2006 - 2009 Cadillac XLR XLR-V: Service Bulletin: Slips in Reverse or Third, Delayed Reverse or Drive Engagement

#09-07-30-004J: Slips in Reverse or Third, Delayed Reverse or Drive Engagement, DTC P0776, P2715, P2723, Harsh 2-3 Shifts (Inspect 1-2-3-4 / 3-5-R Housing and Pump Seal Rings) - (Feb 25, 2014)

This bulletin has been revised to update the 2006 - 2009 Vehicles correction

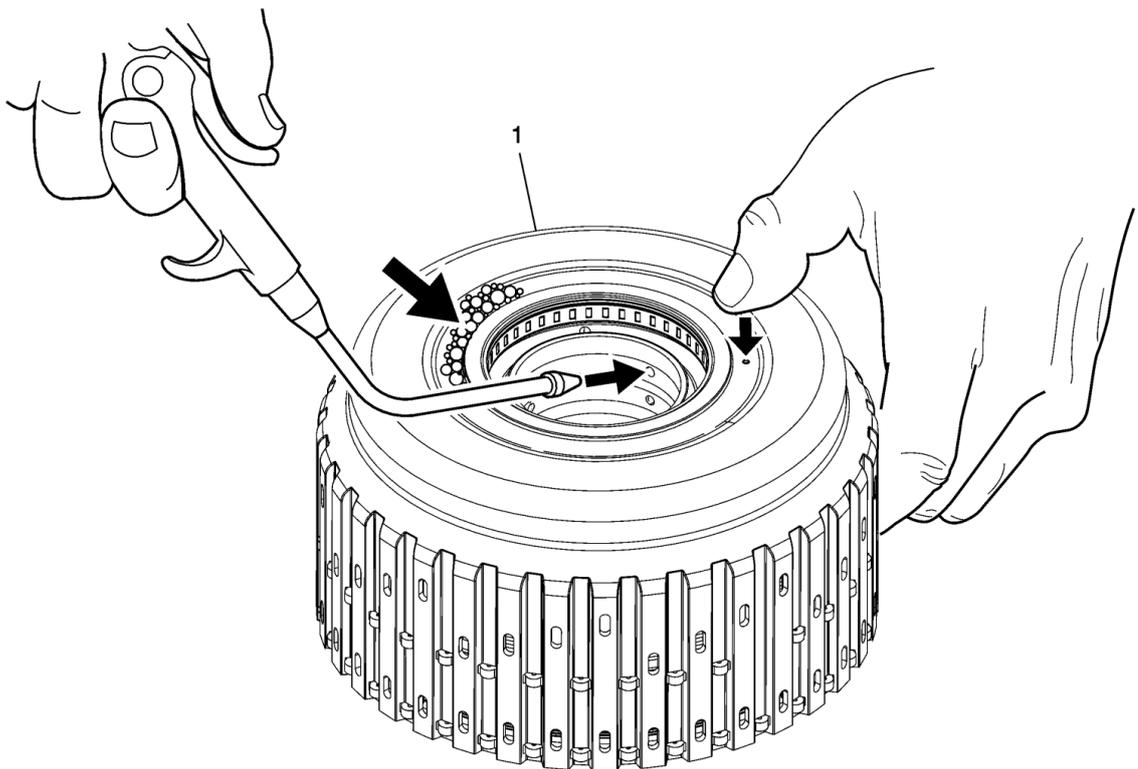
This condition may be caused by a cracked 1-2-3-4 / 3-5-R clutch housing.

Important: If a cracked housing is identified, it must be replaced. Complete, assembled 1-2-3-4 / 3-5-R clutch housings are now available for most applications. These clutch housings come complete with all pistons, seals, clutches, bearing and internal parts. No assembly of the clutch housing is required before it is installed. For applications without a complete, assembled 1-2-3-4 / 3-5-R clutch housing, individual parts must be ordered and the housing assembled in the

Housing Disassembled

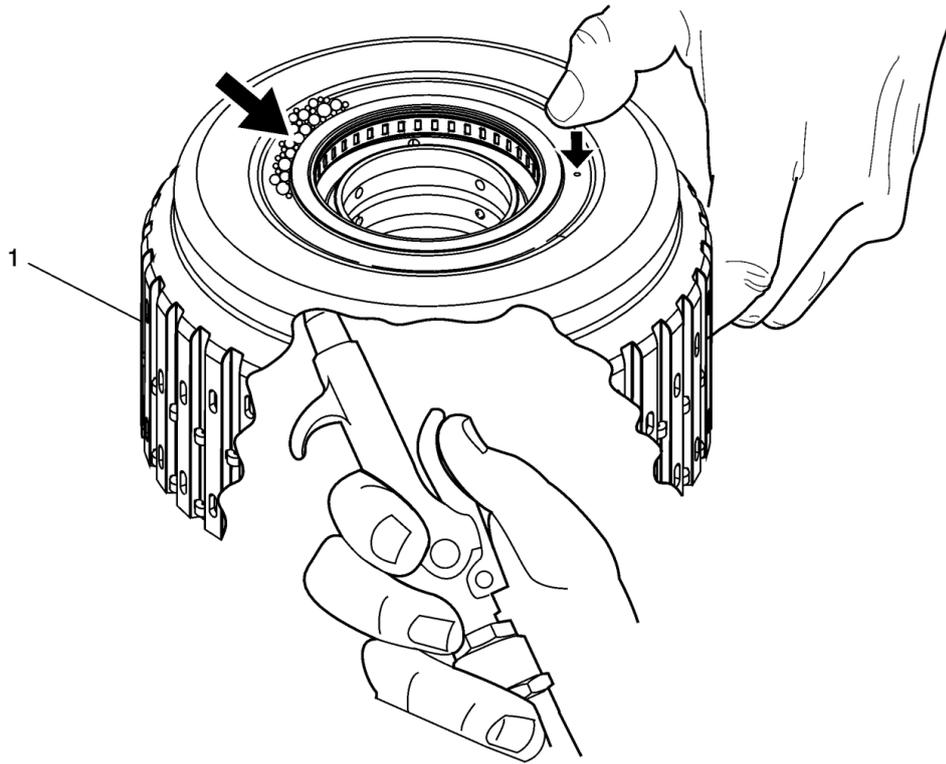
Inspect the 1-2-3-4 / 3-5-R clutch housing for a possible cracked weld.

1. Apply soap compound to weld area of the housing.
2. Hold your thumb over the air bleed passage.
3. Spray compressed air into the housing and inspect the weld area for bubbles.
4. If bubbles are detected, a new housing is required.

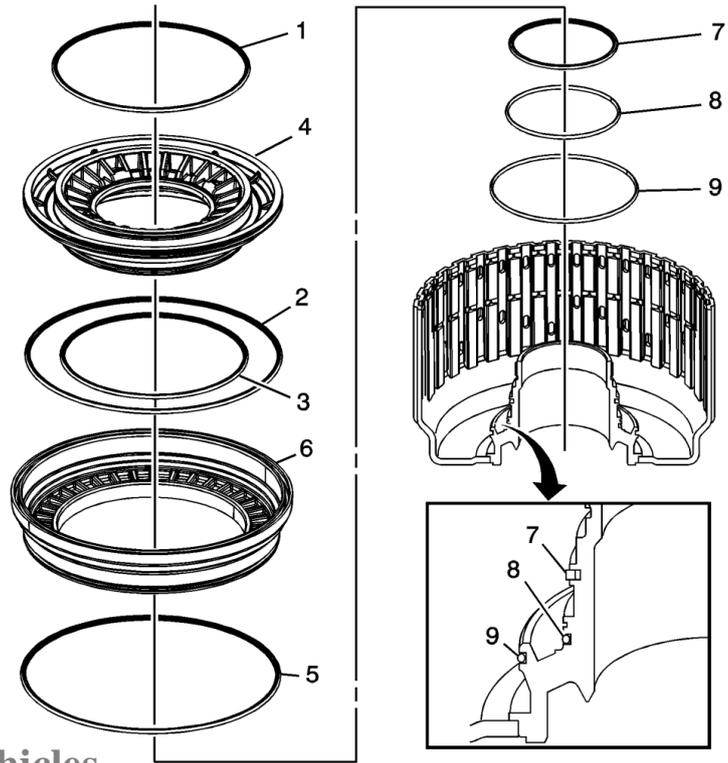
Important: The 6L80 transmission had a design change to the 1-2-3-4 piston, 1-2-3-4 piston housing and the 3-5-R piston for the 2008 model year. Installation of a 2008, 6L80 complete housing assembly into a 2007 or older 6L80 may result in a 2-3 shift flare or 3-5-R clutch distress.

Important: When installing a new 1-2-3-4 / 3-5-R housing into a 2007 or older 6L80, be sure to install all three (3) inner seals (7, 8, 9 in illustration below). Failure to install these seals can result in no reverse, no forward or distressed clutches.

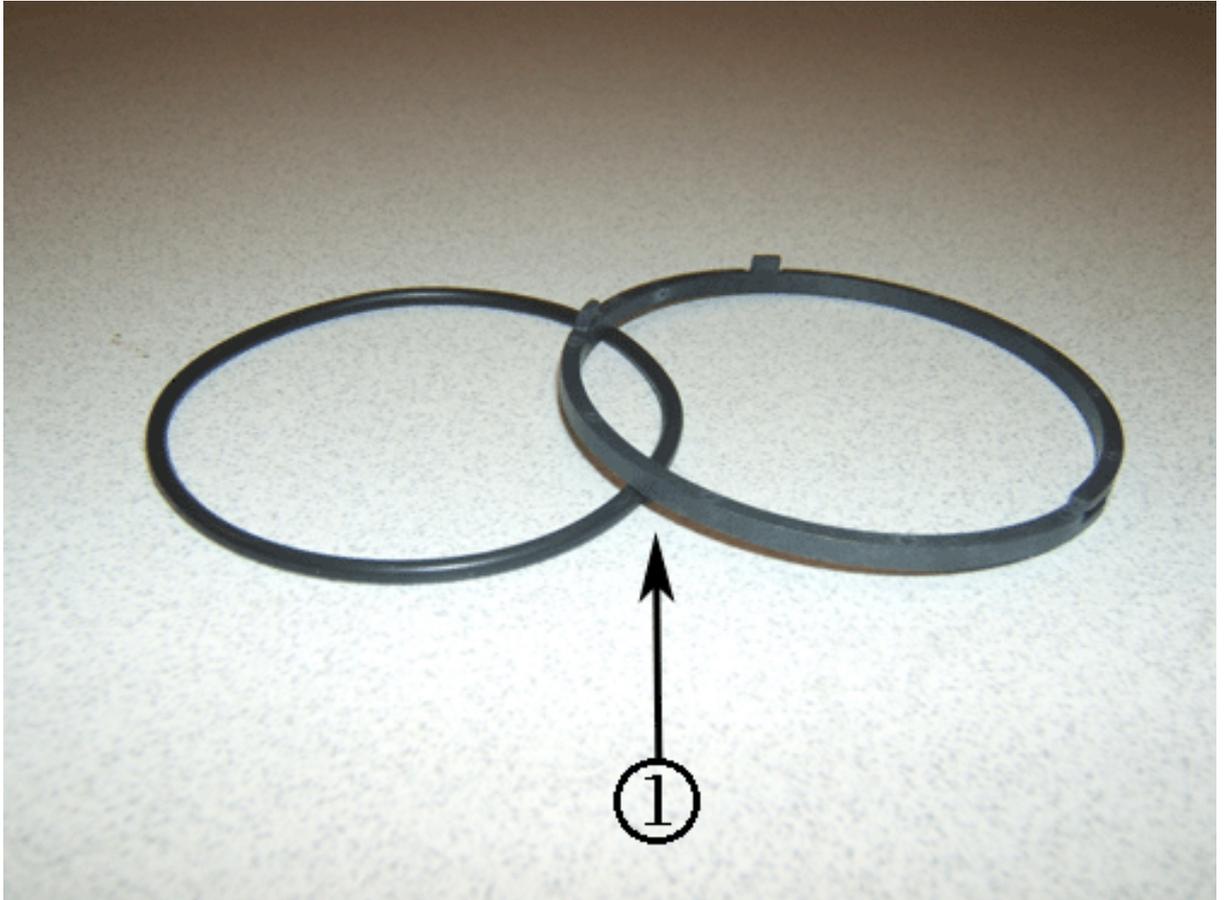
A harsh 2-3 shift condition may be caused by leaking 1-2-3-4 and 3-5-R clutch fluid seal rings (1) on the transmission fluid pump cover assembly.

Inspect the fluid seal rings. Transmissions in 2006, 2007, 2008 and early build 2009 models used a 1- piece design seal ring in production. Starting December 2008, a 2-piece seal ring design was implemented. The 1-piece seal ring design may cause a harsh 2-3 shift due to leakage. This is typically a low mileage issue. If the seal rings are a 1-piece design they should be replaced with new 1-piece design seal rings. It is not necessary to replace the pump cover.

Notice: The clutch fluid seal rings must be installed in a specific way. Failure to install new clutch fluid seal rings in the proper orientation may cause a repeat harsh 2-3 shift. Refer to 1-2-3-4 and 3-5 Reverse Clutch Fluid Seal Ring Installation (6L80/90) in SI for correct installation.
